Groundwater Transfer Review Summary Form

Transfer/PA # T- 14377 RA re-review

Application: T-14377 re-review

Applicant Name: Shortland Golf Club

Annotated Agent Cross Section- Annotations in red were made by the reviewing hydrogeologist, not the applicant's agent.

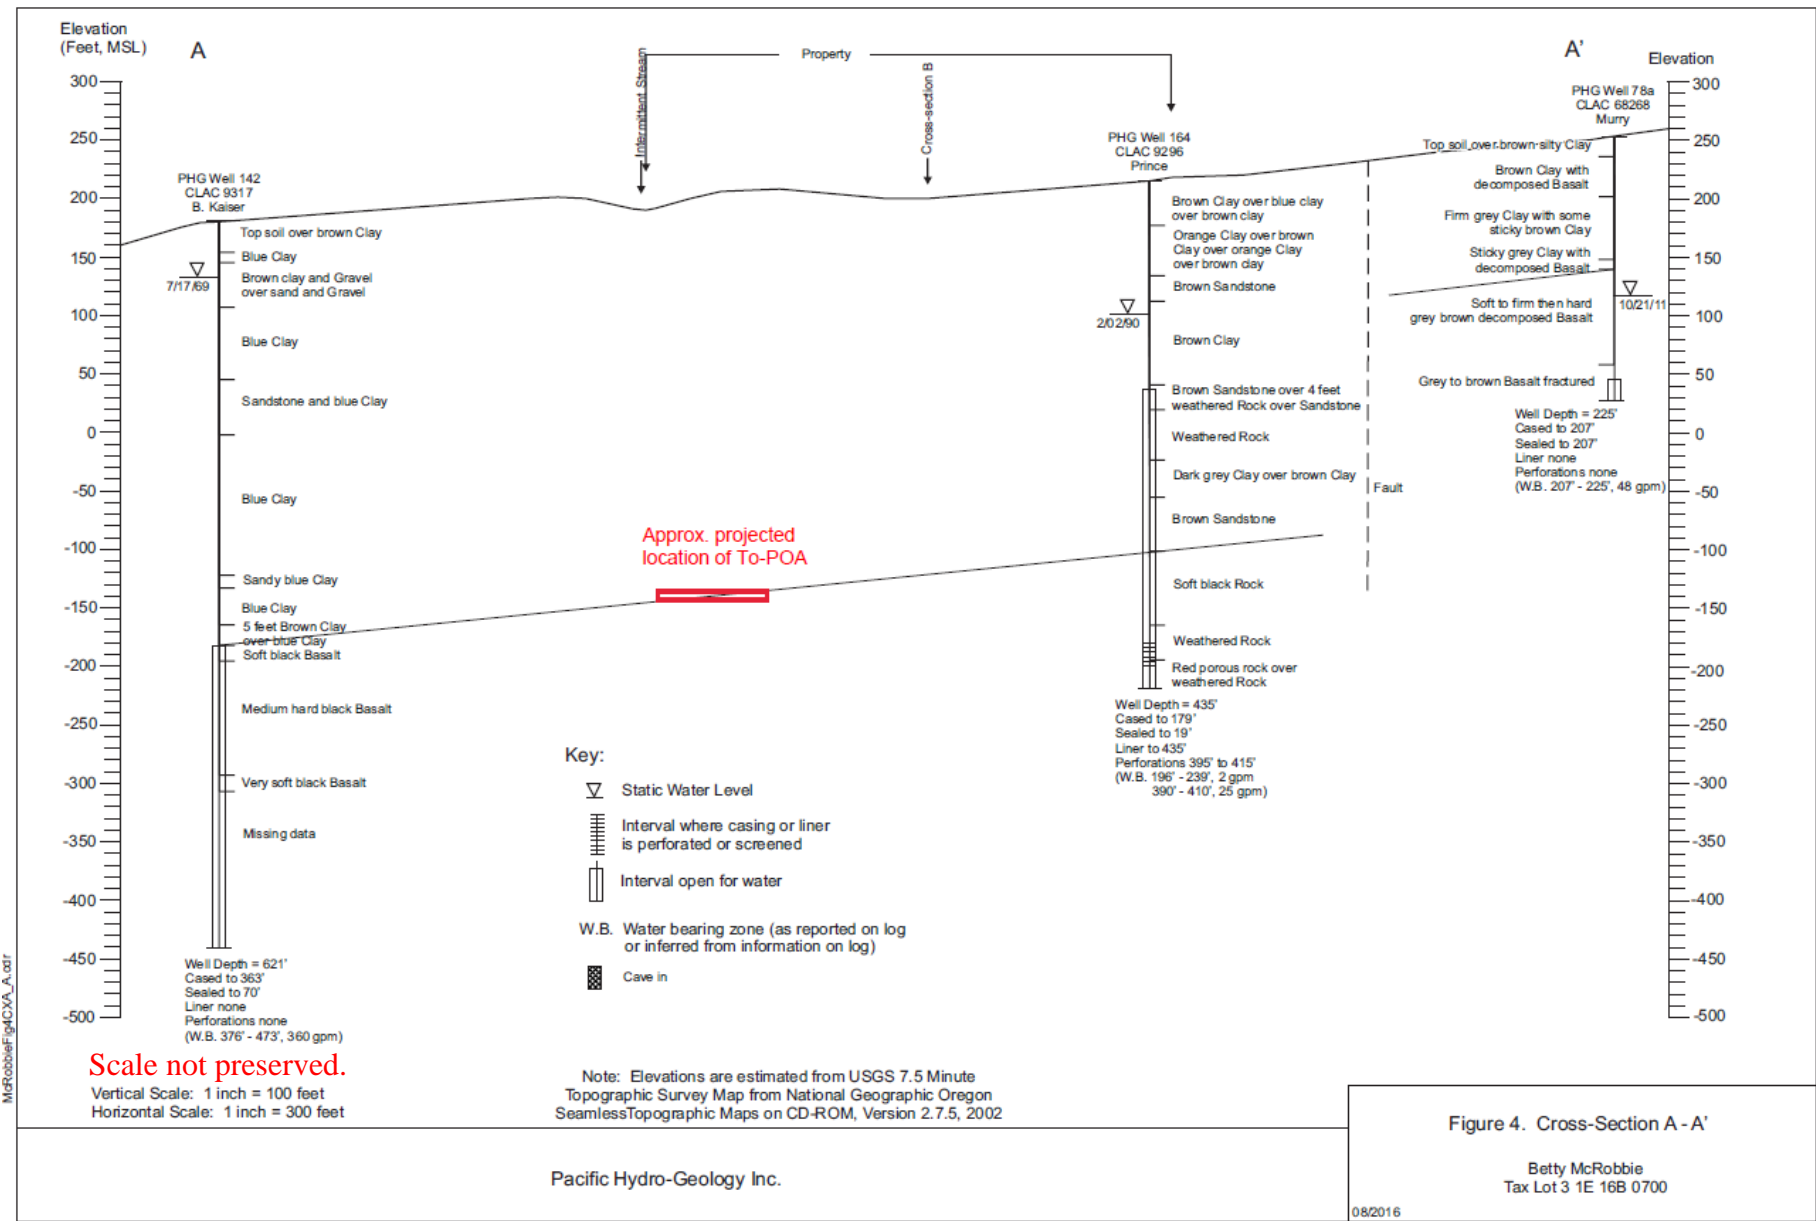
- Will the proposed POA develop the same aquifer (source) as the existing authorized POA?
☒ Yes ☐ No Comments: Currently authorized POA Well 1 and From-POA Well 2 are completed to depths of 621 and 1005 feet bls, respectively, and develop the Columbia River Basalt (CRB) aquifer system, which is first reported in the well logs at depths of 362 and 540 feet bls.

The To-POA is proposed to be completed to a total depth between 290 and 1000 ft bls, with casing and seal extending "0 to 5 feet into basalt." **NOTE: Current well construction regulations for sealing into consolidated formations (OAR 690-210-0150) require casing and seal extend to at least five feet into solid, unfractured, consolidated rock overlying the water-bearing rock formation.** The applicant's agent has provided analysis indicating that, at the location of the proposed To-POA, the solid, unfractured Columbia River Basalt likely exists at greater than ~370-380 ft bls (~ -140 to -150 ft msl) based on the well reports for CLAC 9317 (authorized POA) and CLAC 9296 (neighboring well) (see attached Annotated Agent Cross Section). This largely agrees with the well report for CLAC 18564, which appears to be the closest well to the proposed To-POA and indicates weathered basalt from 357 to 363 ft bls (~ -113 to -119 ft msl) and more competent basalt from 363-370 ft bls (~ -119 to -126 ft msl). Based on the well report for CLAC 18564 and the land surface elevation at the proposed To-POA, the proposed To-POA would need to be cased and sealed to at least ~350 ft bls to meet well construction standards and only produce from the basalt aquifer. If constructed and sealed into the solid, unfractured basalt, the proposed To-POA will develop the same source as the authorized POA.

Well Interference Analysis

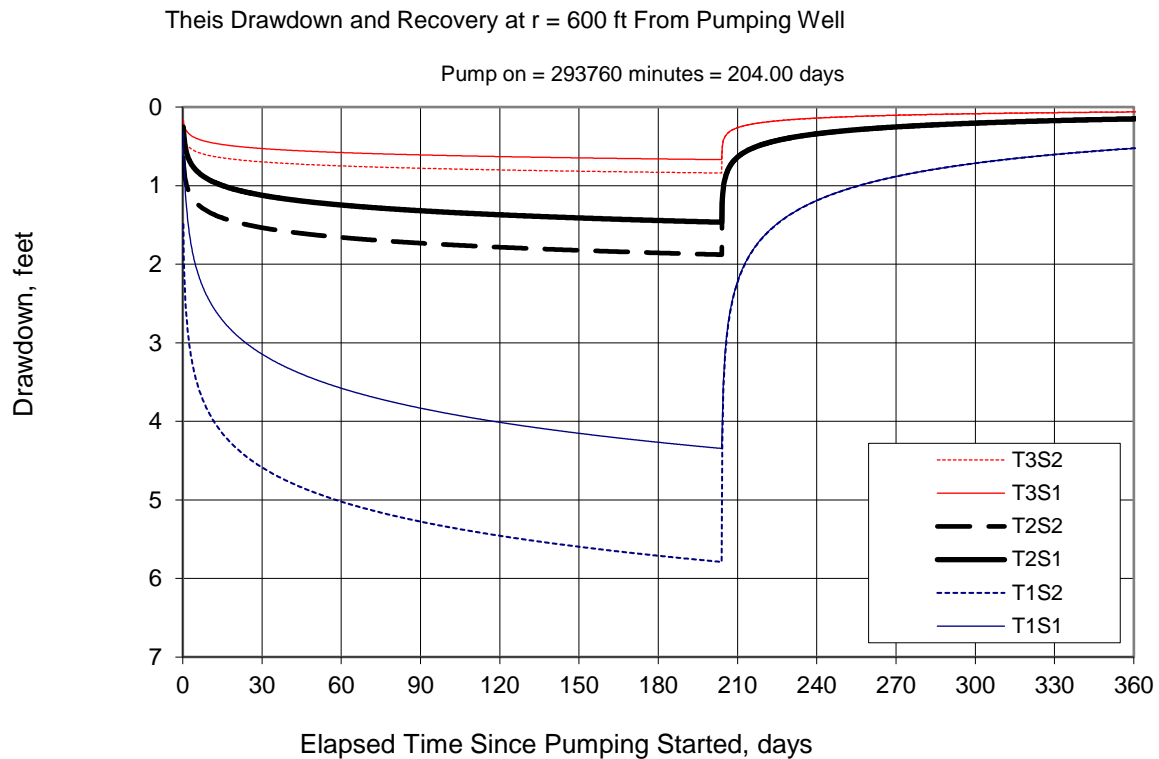
5. a) Will this proposed change, at its maximum allowed rate of use, likely result in an increase in interference with **another ground water right**?
☒ Yes ☐ No Comments: The currently authorized POA are located ~1,800 ft (Well 1) and ~2,660 ft (Well 2) from neighboring domestic basalt well CLAC 18564. The proposed To-POA would be only ~600 ft from CLAC 18564. The reduced intervening distance between CLAC 18564 and the To-POA would likely increase interference with CLAC 18564.

- b) If yes, would this proposed change, at its maximum allowed rate of use, likely result in another groundwater right not receiving the water to which it is legally entitled?
☐ Yes ☒ No If yes, explain: The potential interference between the proposed To-POA and CLAC 18564 was evaluated at the proportional maximum rate of 0.073 cfs using the Theis (1935) solution for drawdown in a confined aquifer (see attached Well Interference Analysis. Based on the results of the analysis, the proposed change is unlikely to result in injury to CLAC 18564 or similarly located basalt wells.

Radial distance, $r = 600$ ft [approximate distance from To-POA to CLAC 18564]Pumping time, $t_{\text{pump}} = 204$ days [time to exhaust duty at maximum proportional rate]Pumping rate, $Q = 0.073$ cfs [maximum proportional rate under Certificate 50575]Transmissivity, $T1 = 800 \text{ ft}^2/\text{d}$ | $T2 = 2,800 \text{ ft}^2/\text{d}$ | $T3 = 6,800 \text{ ft}^2/\text{d}$ [Pumping Test Reports]Storativity, $S1 = 0.001$ | $S2 = 0.0001$ [Conlon et al., 2005]
